RECEIPT DATE: 2/12/19 **ONSITE SEWAGE DISPOSAL SYSTEM** P 564784

PROPERTY ADDRESS: 5525 Jacks Landing Way

**RE:** Jack's Landing Lot 4 OSDS plan

**ONSITE SEWAGE DISPOSAL SYSTEM DESIGN PLAN**

**TABLE D WORKSHEET**

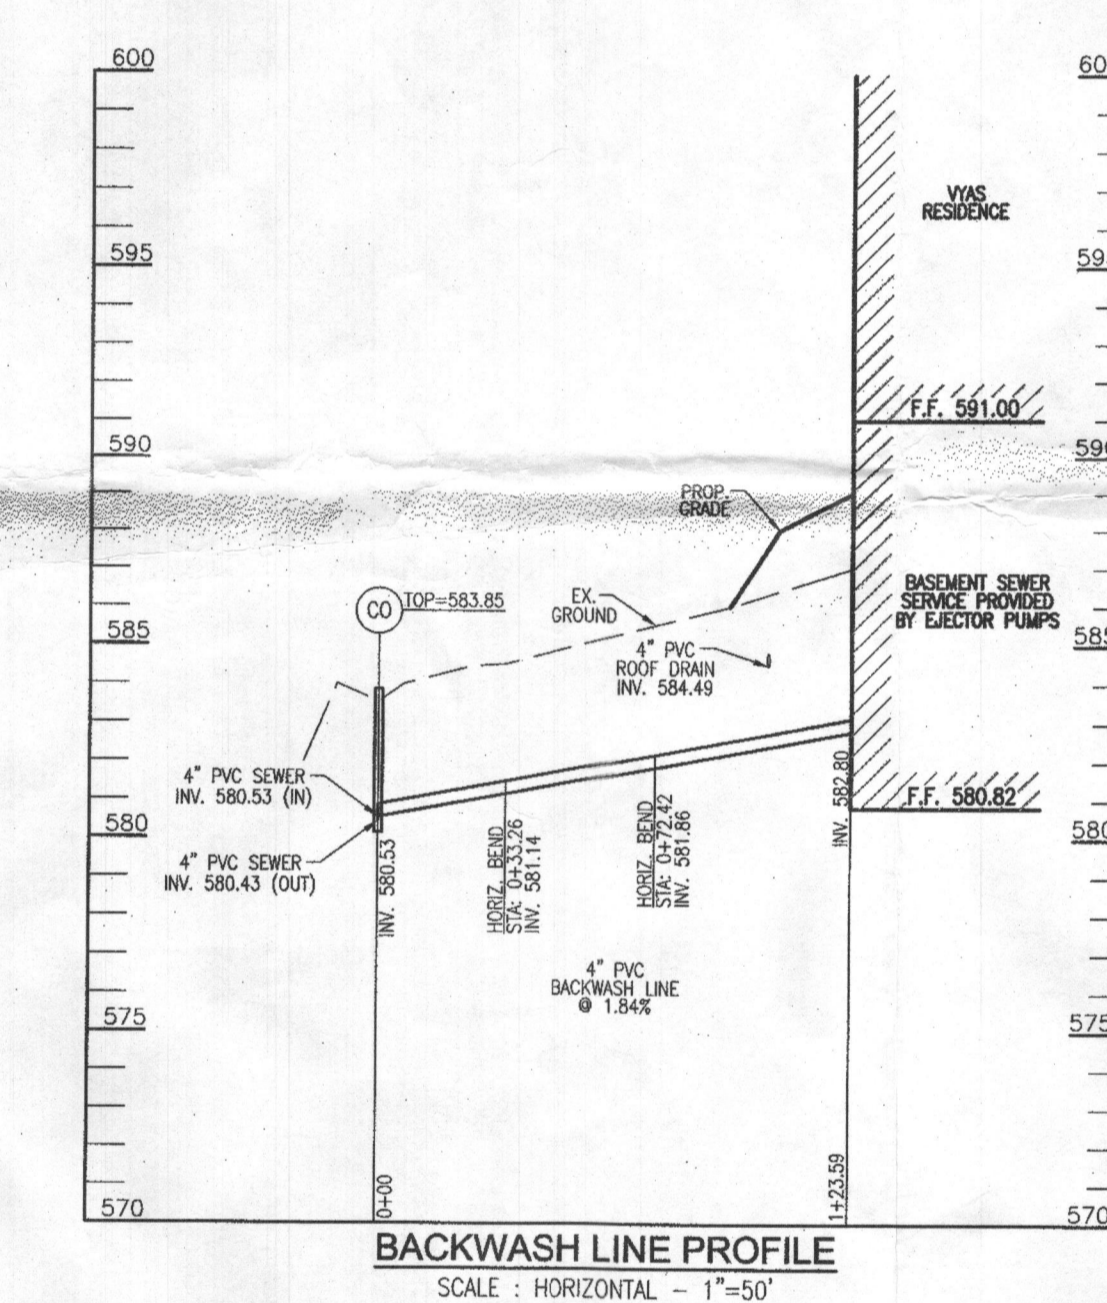
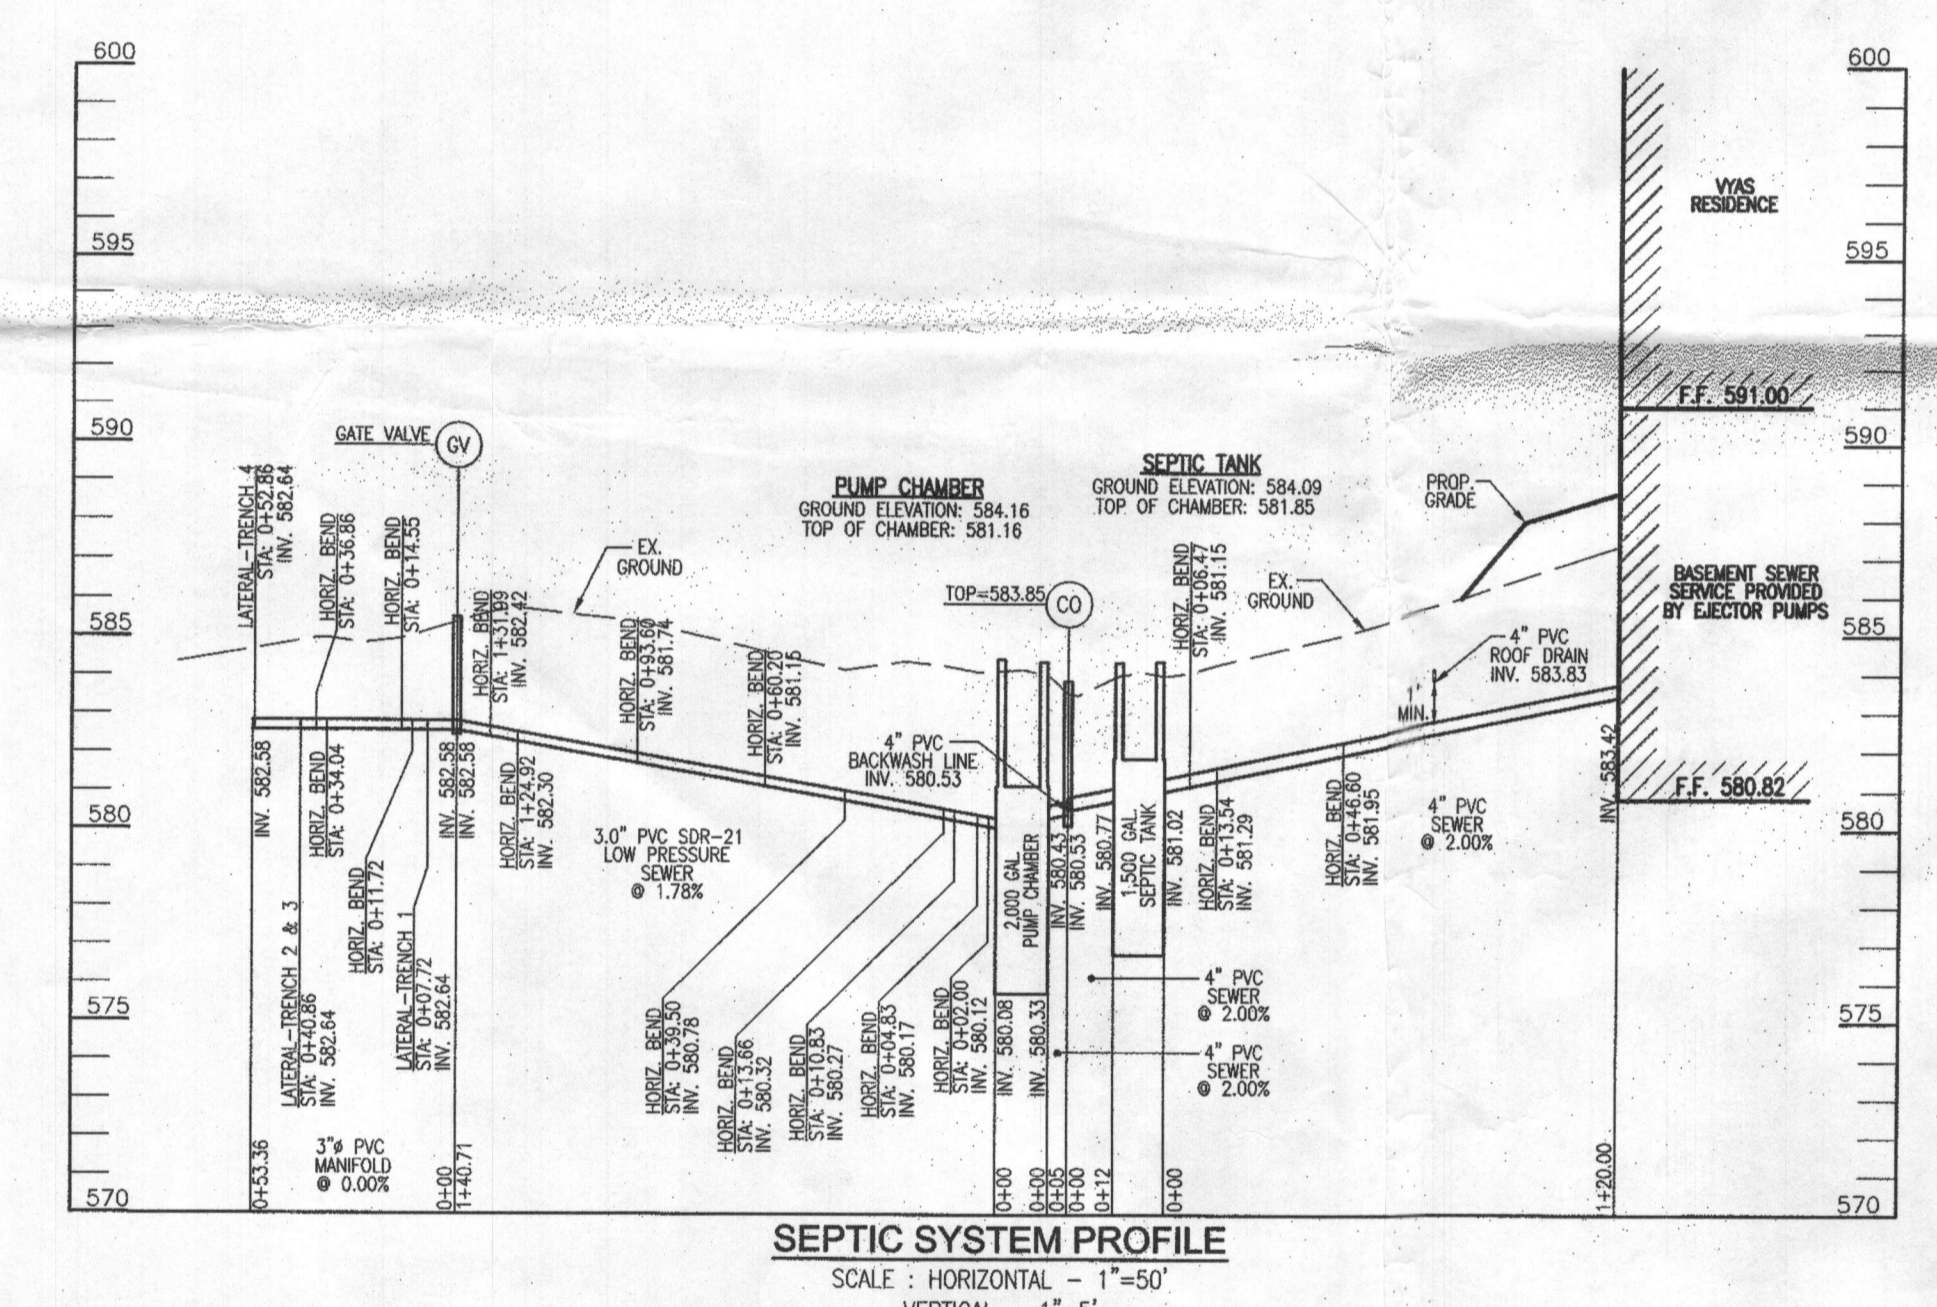
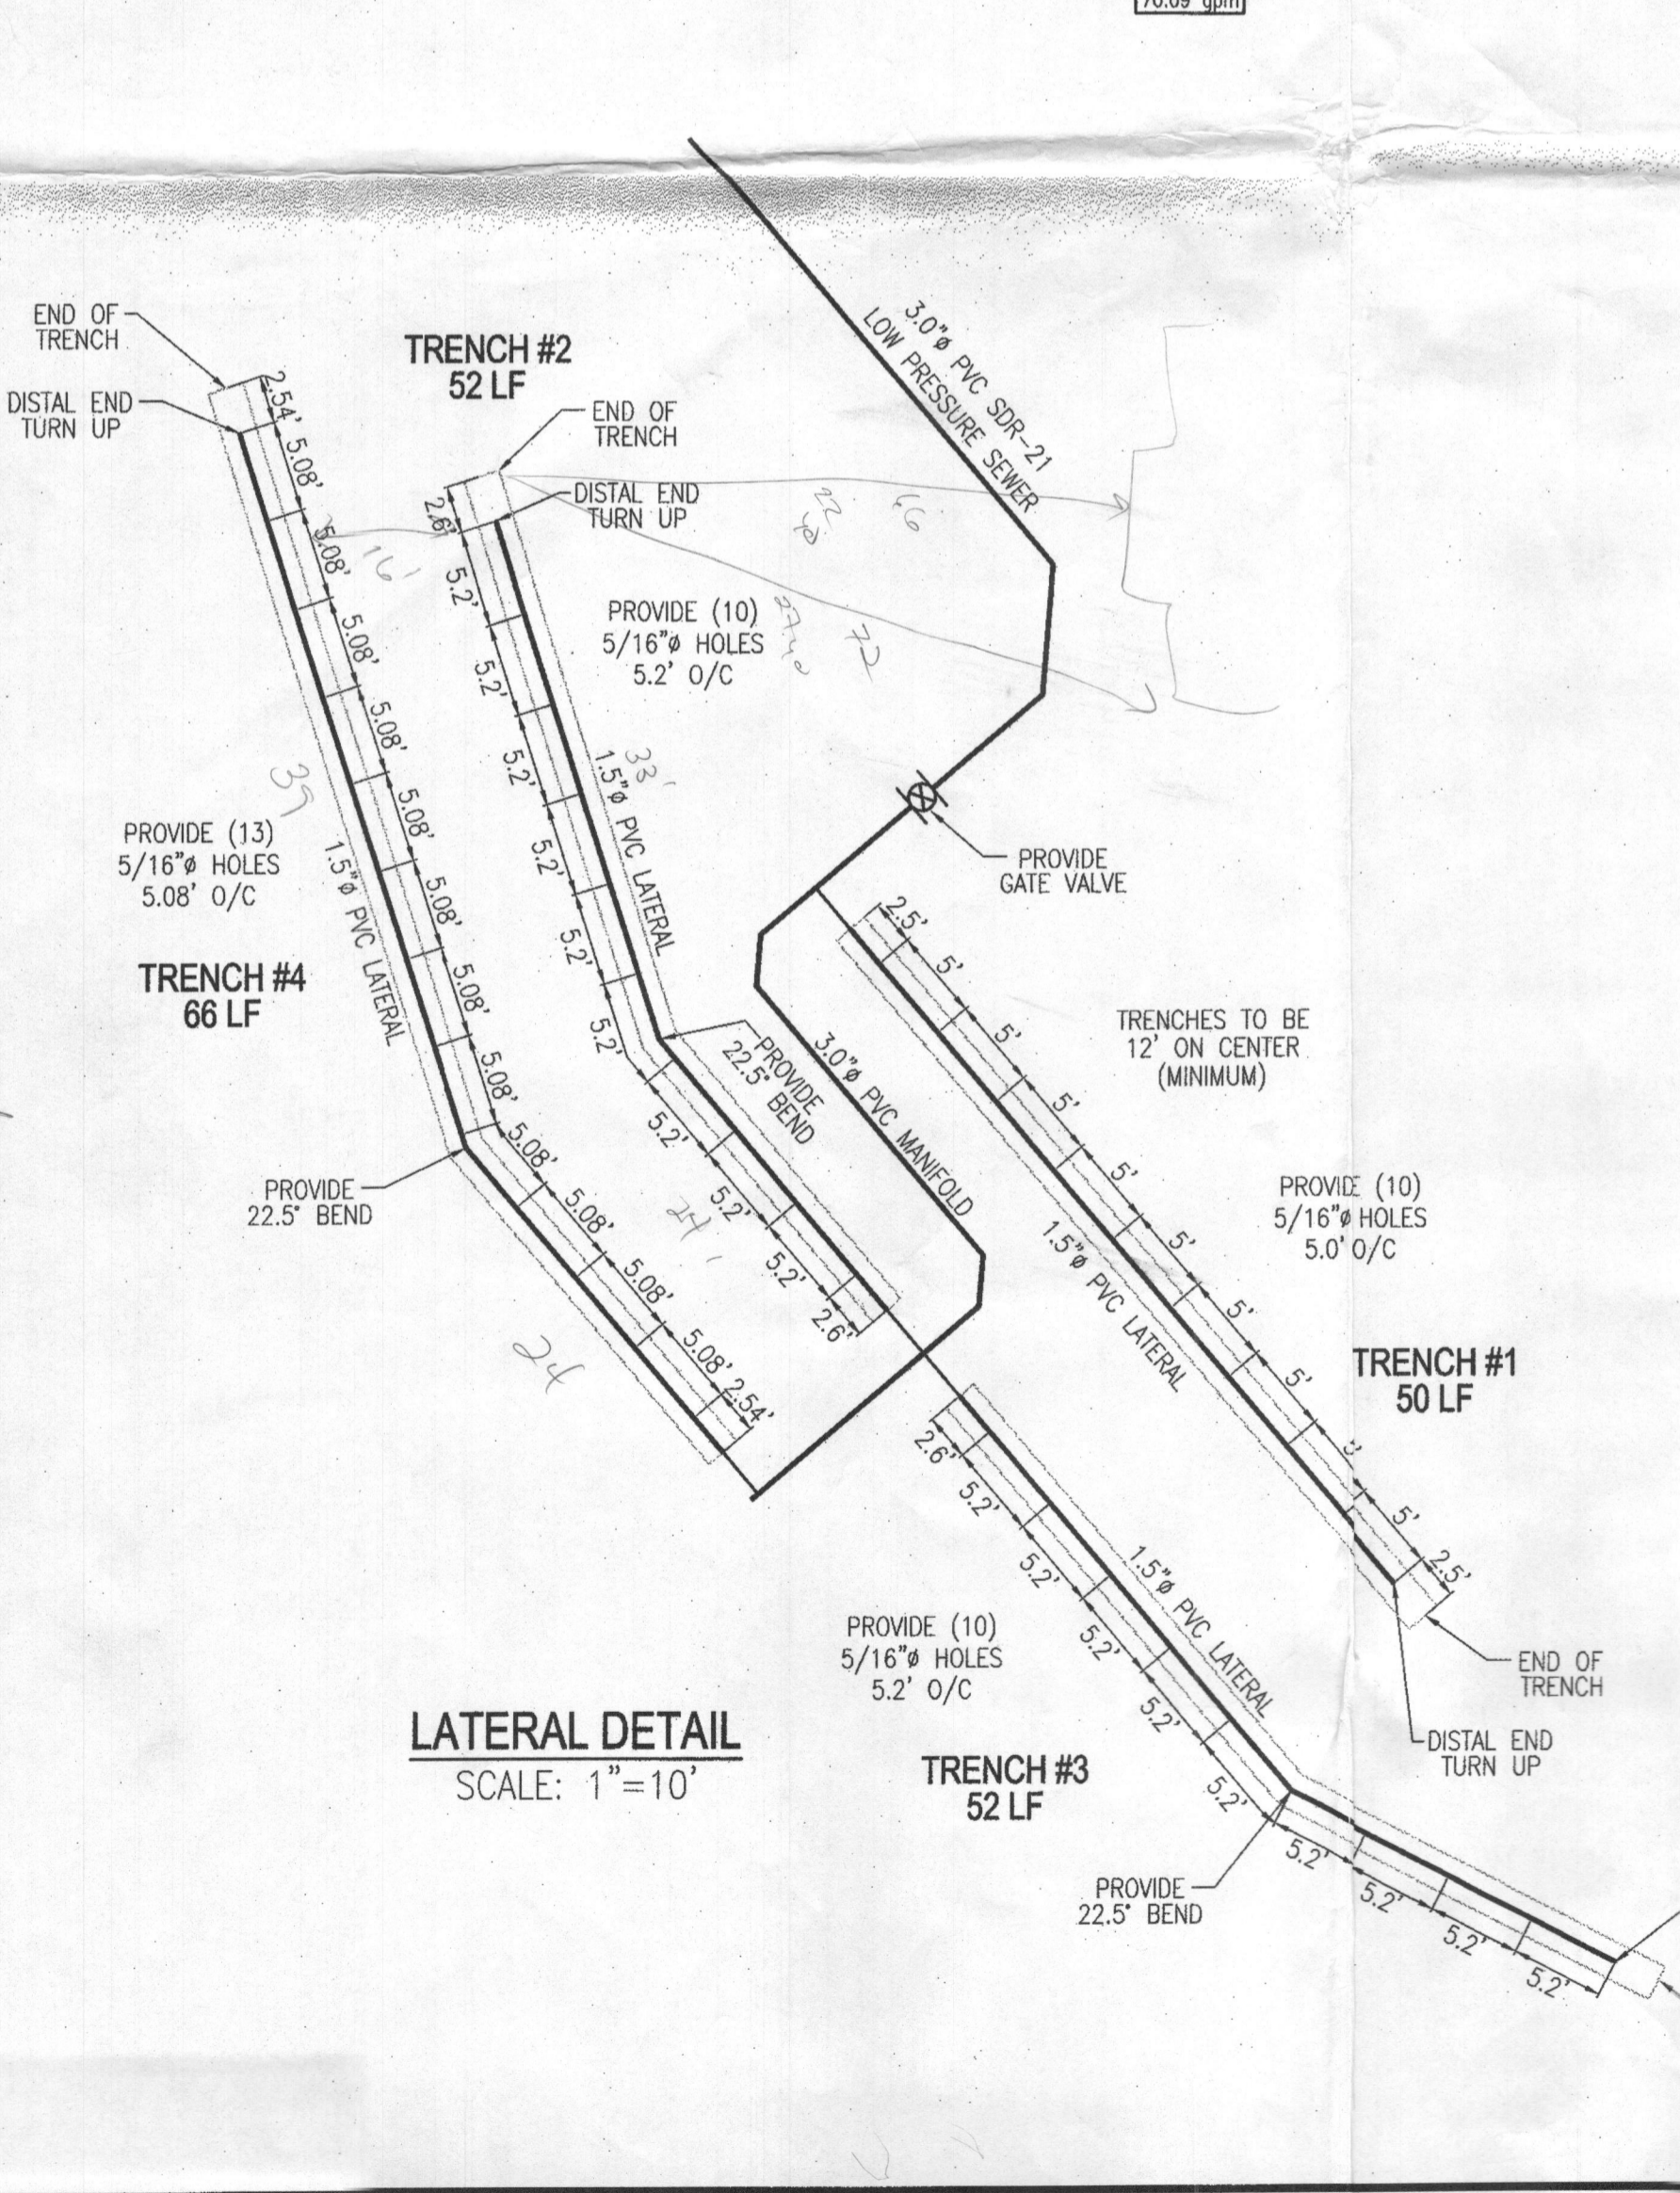
1. On page 1 the trench cross section shows a 4" diameter pipe.
2. Trench 4 is longer than the other trenches, yet is designed for equal flow. Redesign the lateral perforations so that there is equal flow per linear foot and add a column on table D to show flow per linear foot per lateral.
3. The trenches bend too much along contour for a practical installation. One possible solution is to center feed trenches 3 and 4 at the bend point and do the same for trench 1 while straightening it out a bit a few inches off contour.
4. Information on the reverse osmosis system is required as part of the design plan. We will need the make and model, manufacturer specs, installation requirements, backwash ratio, backwash frequency and volume, etc.
5. Table D on page 2 needs to show lateral length

TRENCH	RELATIVE ELEV.	TRENCH LENGTH	LATERAL LENGTH	ASSUMED HEAD	ORIFICE DIAMETER	ORIFICE FLOW RATE	ORIFICE SPACING	NUMBER OF ORIFICES	FLOW RATE PER LF	TRENCH FLOW RATE
1	582.64	50	47.5'	2.00'	5/16"	1.63 gpm	5.0'	10	0.33 gpm/ft	16.3 gpm
2	582.64	52	49.4'	2.00'	5/16"	1.63 gpm	5.2'	10	0.31 gpm/ft	16.3 gpm
3	582.64	52	49.4'	2.00'	5/16"	1.63 gpm	5.2'	10	0.31 gpm/ft	16.3 gpm
4	582.64	66	63.46'	2.00'	5/16"	1.63 gpm	5.08'	13	0.32 gpm/ft	21.19 gpm
										70.09 gpm
